Amendments to the Drawings:

REMARKS/ARGUMENTS

1-2. DRAWING OBJECTION FOR FIGS. 7A-7B:

FIG. 7A

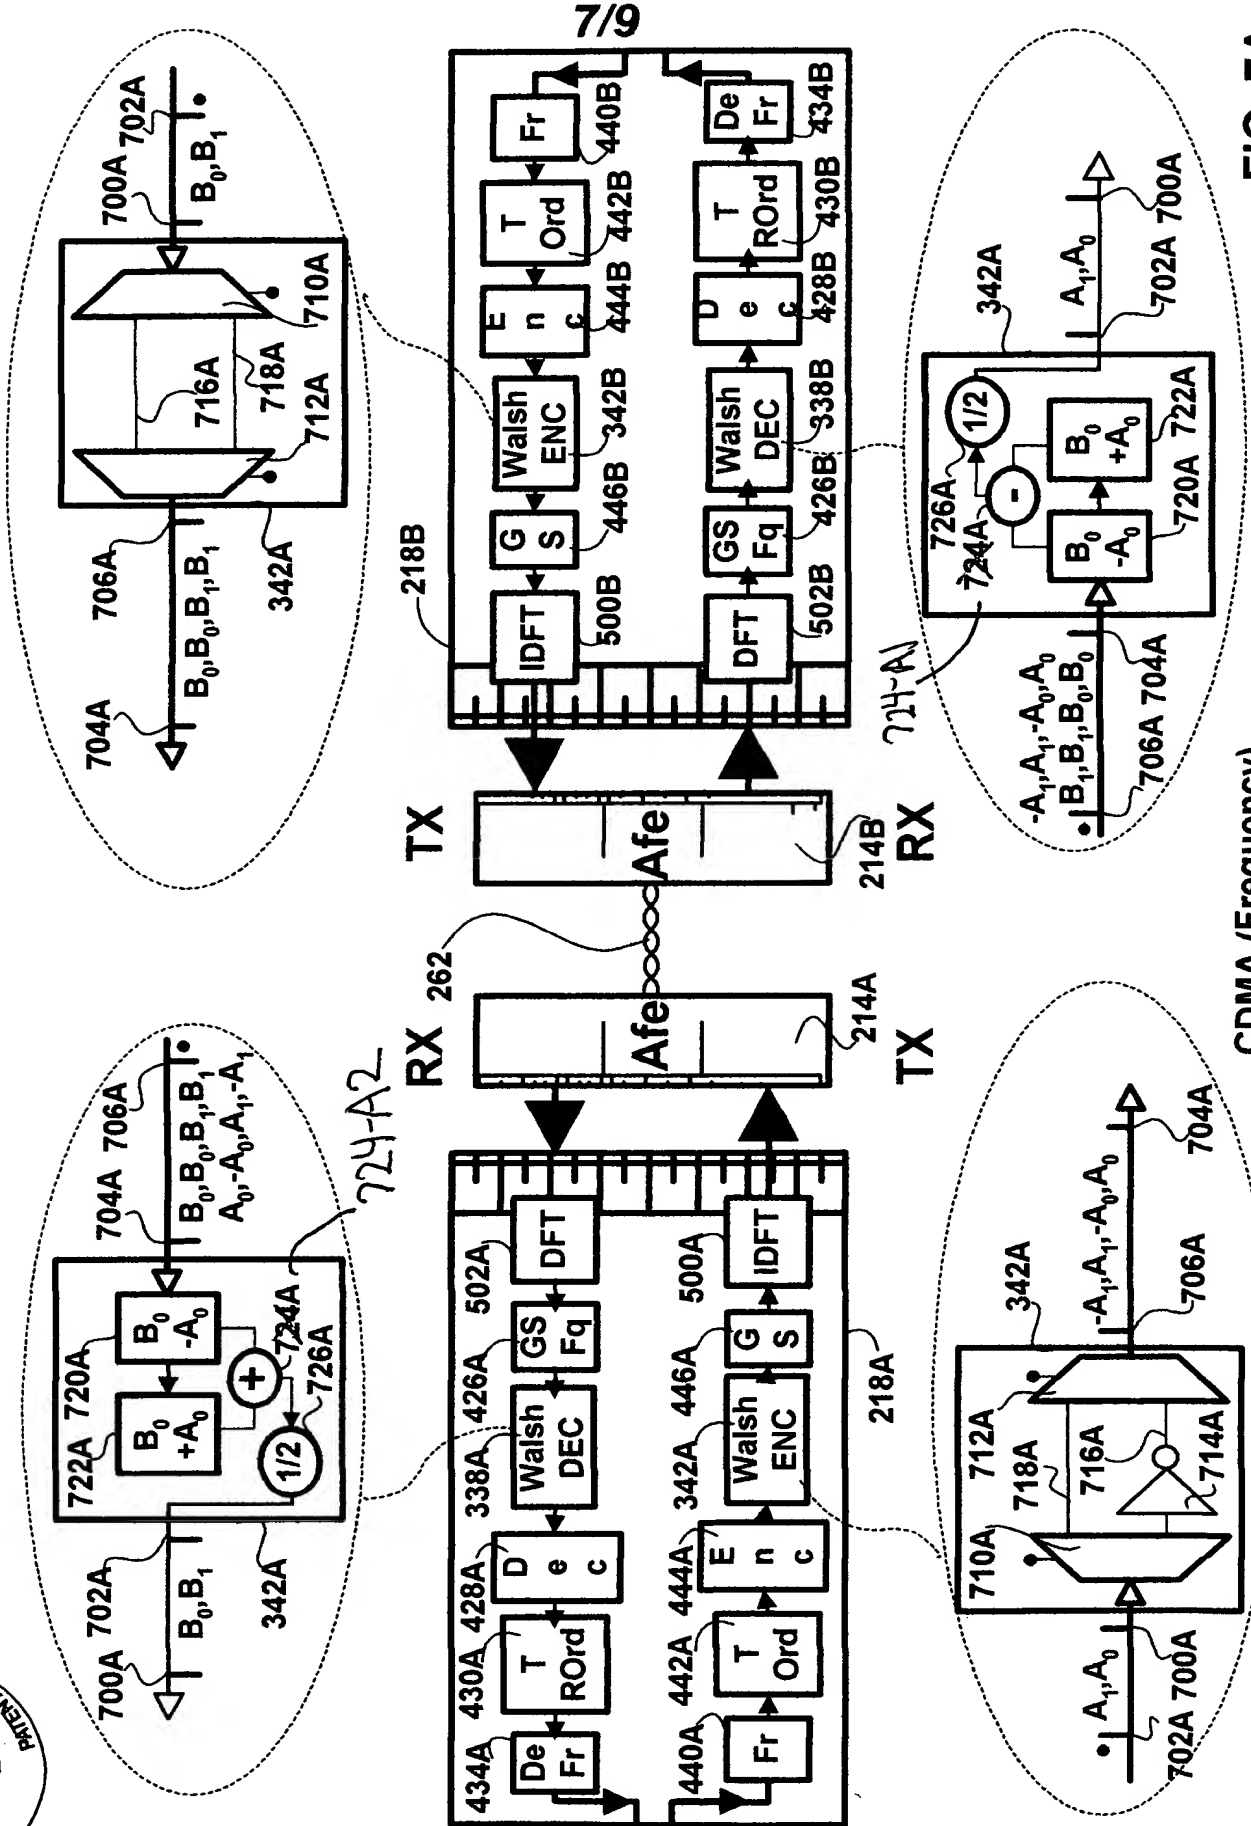
The drawings, specifically Figures 7A-7B, were objected to because reference number 724A was used to designate both an adder and a subtractor.

The attached sheets of drawings include changes to Figs. 7A and 7B. These sheets replace the original sheets including Figs 7A and 7B.

The Applicant has amended to correspond with the specification to correspond with the drawings in which subtractor 724A in the Walsh decoder 338A of FIGS. 7A-7B and the adder 724A in the Walsh decoder 338B of FIGS. 7A-7B are appropriately referred to in the specification and assigned revised reference numbers in the attached replacement sheets and the amended specification. The Applicant therefore respectfully requests that this objection be withdrawn.
